# No Start or Extended Crank and/or MIL "ON" DTC P030# or P0015

**Service Category** Engine/Hybrid System

**Section** Engine Control

**Figure 1. Location of Authorized Modifications Label on 2009 Corolla and Matrix**

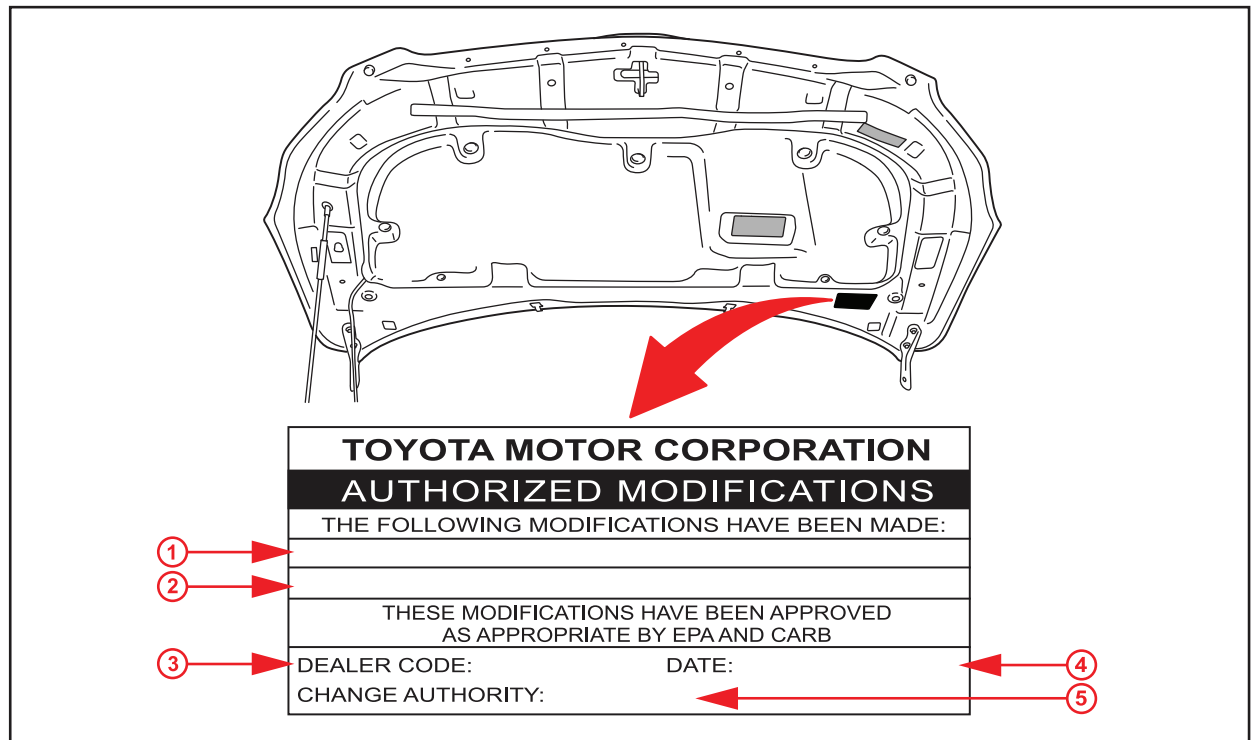
1. Confirm the condition matches the Introduction.
2. Check for the Authorized Modifications Label affixed to the vehicle in the location shown in Figure 1. Confirm if the ECM (PCM) calibration has been updated. If the calibration ID listed is NOT the latest ECM (PCM) calibration — go to step 3.

- Install the Authorized Modifications Label.
  - Using a permanent marker, enter the following information on the label:
    - ECM part number [*Refer to the **Parts Information** section for the **CURRENT PART NUMBER***]
    - Calibration ID(s) [*Refer to the **Calibration Identification Chart** for the **NEW CALIBRATION ID***]
    - Dealer Code
    - Repair Date
    - Change Authority [***This TSB number***]
  - Affix the Authorized Modifications Label to the vehicle at the location shown in Figure 1. The Authorized Modifications Label is available through the MDC, P/N 00451-00001-LBL.
- Add the EFI Tank Additive to the fuel tank.
- Test drive the vehicle to confirm proper vehicle operation.
